WATER QUALITY MEMORANDUM

Utah Coal Regulatory Program

RE: Fourth Quarter 2018 Water Monitoring, Wolverine Fuels, Fossil Rock Mine, C/015/0009, Task ID #5815

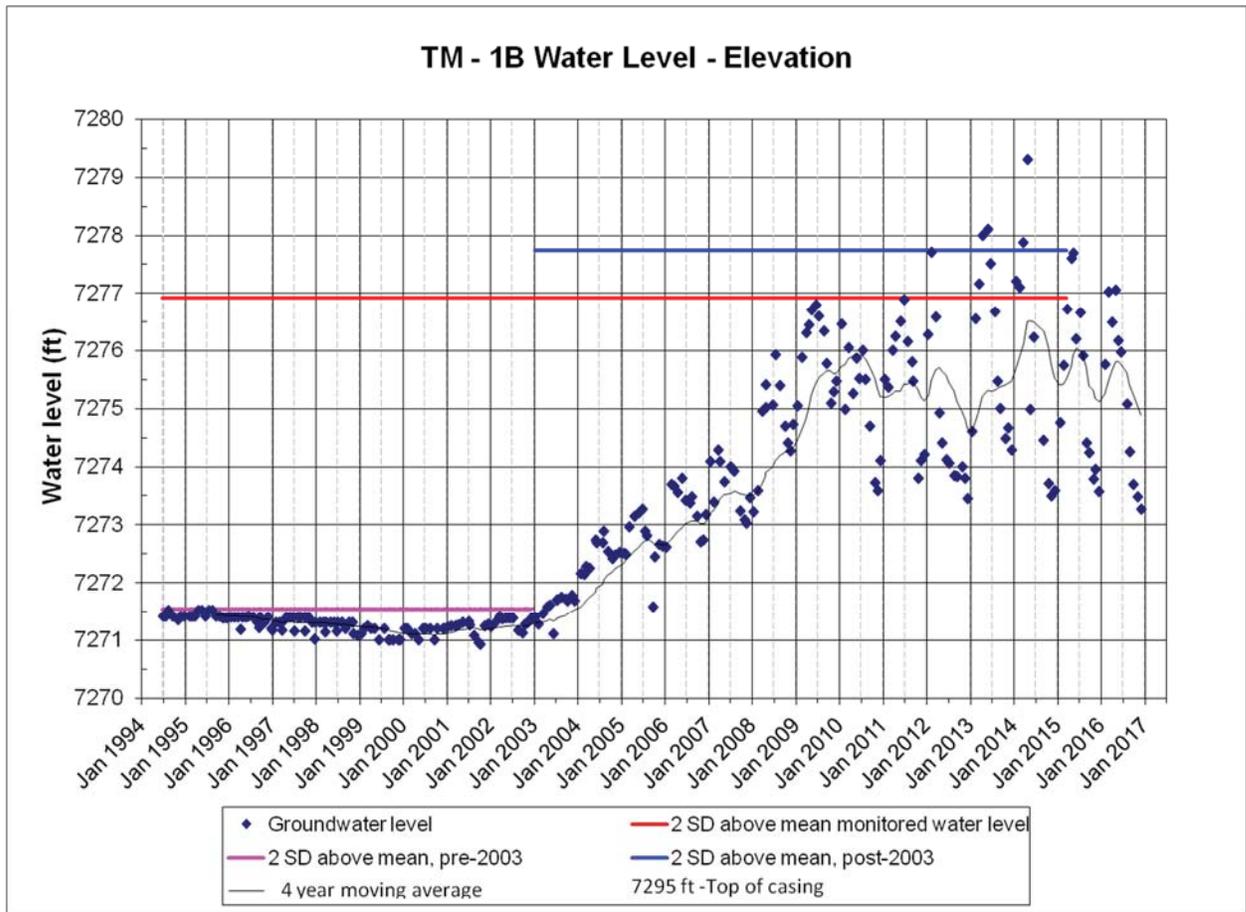
Figure 1. The water level in TM-1B has been rising since mine dewatering ceased in May 2001. It's difficult to say where the water level will come to rest. The well is completed in the Panther tongue of the Star Point sandstone below the mine workings. This sandstone tongue contacts the floor of the mine workings. Mine dewatering reduced the potentiometric head within the unit and the mine pool is probably recharging the unit. *This graph will be updated when mining begins in the Cottonwood tract.*

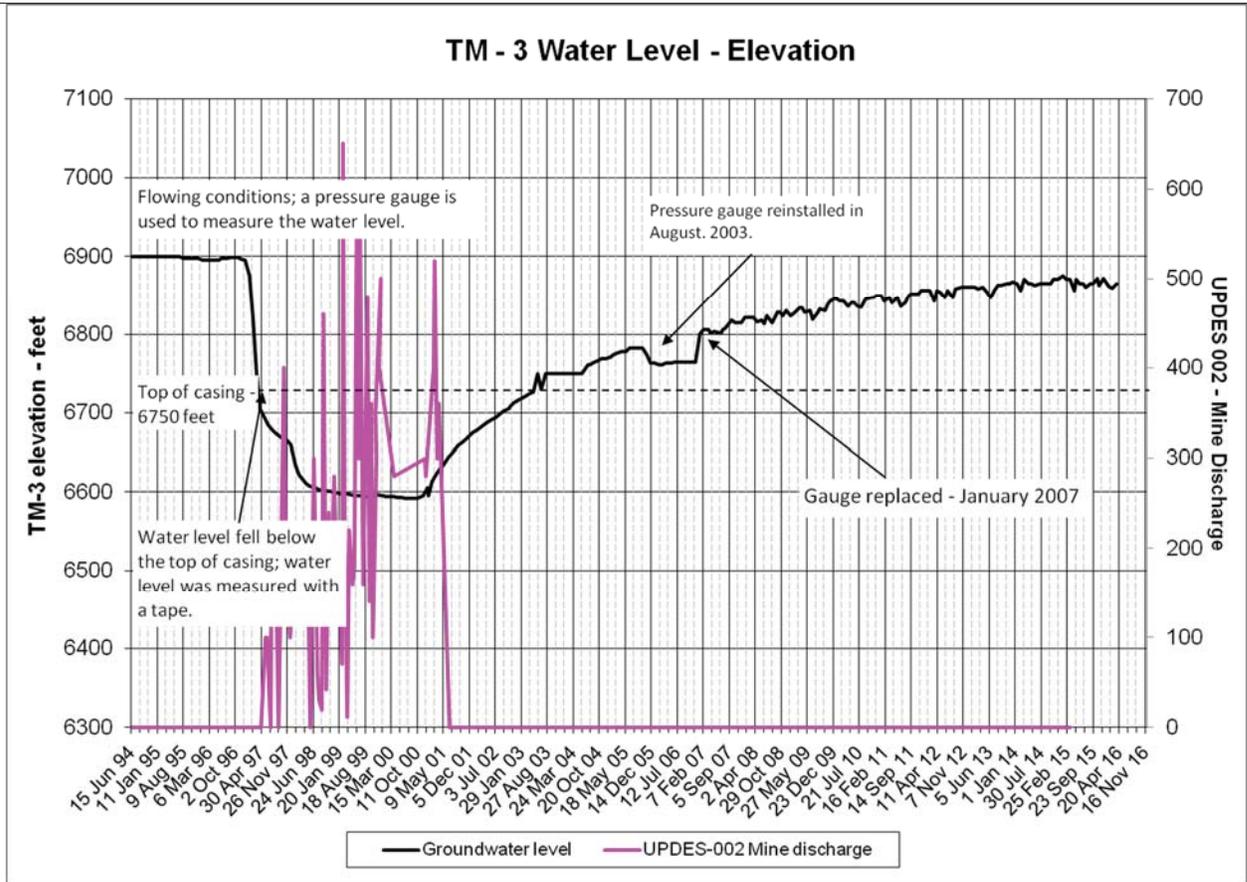
Figure 2. TM-3 water elevation peaked in June 2005, remained steady through October, dropped 18.5 ft in November and December 2005 and remained virtually unchanged during 2006. The pressure gauge was replaced in January 2007 and values jumped to approximately match the pre-2006 curve. During the first half of 2007 the curve was relatively flat, but it has been steadily climbing. The outgoing document Reduce Hydrologic Monitoring Sites, PacifiCorp, Deer Creek, C/015/0018, Task ID #4332 stipulates this well should not be released until 6,900 ft is reached. *This graph will be updated when mining begins in the Cottonwood tract.*

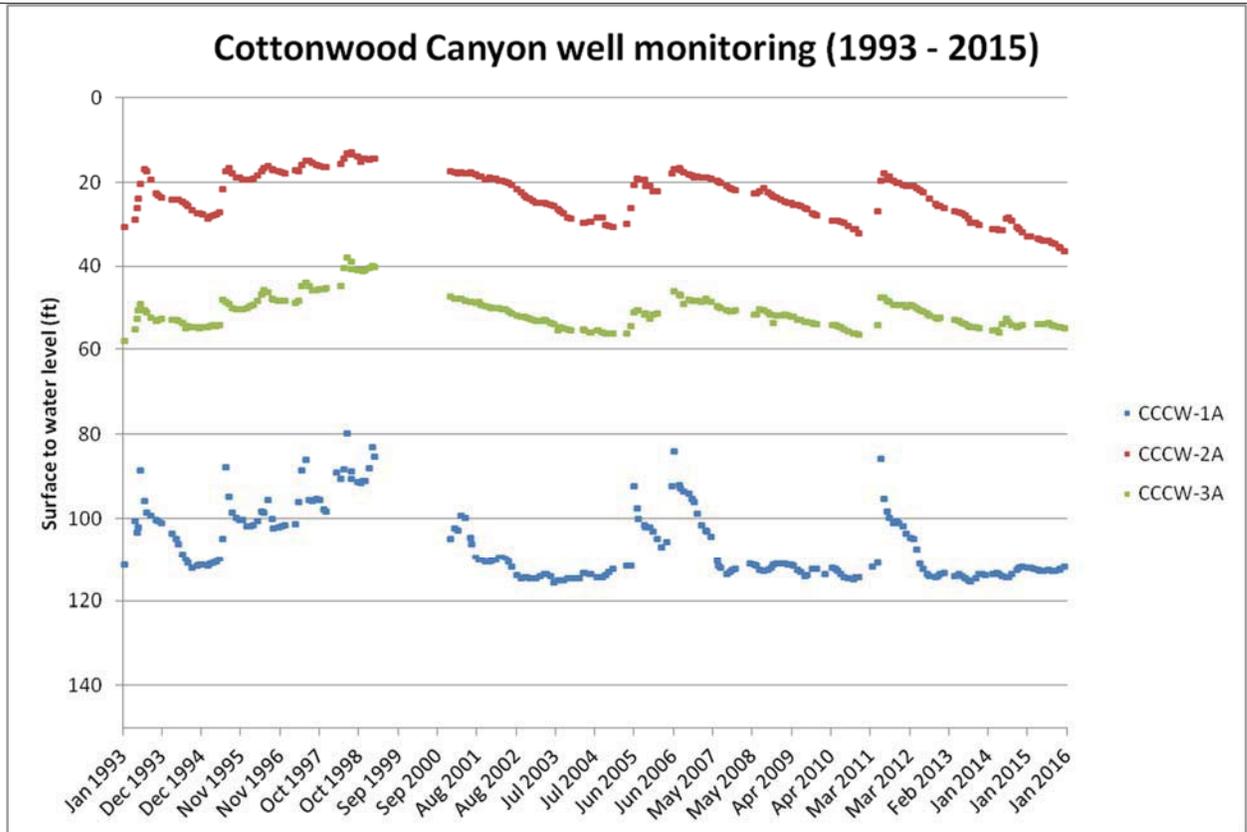
Figure 3. Alluvial aquifer water levels in the Cottonwood Canyon Creek monitoring wells. The drill hole data is found in Trail Mountain MRP Appendix C p. 23. This graph will be updated when mining begins in the Cottonwood Track. The wells primarily respond to climatic variability. *This graph will be updated when mining begins in the Cottonwood tract.*
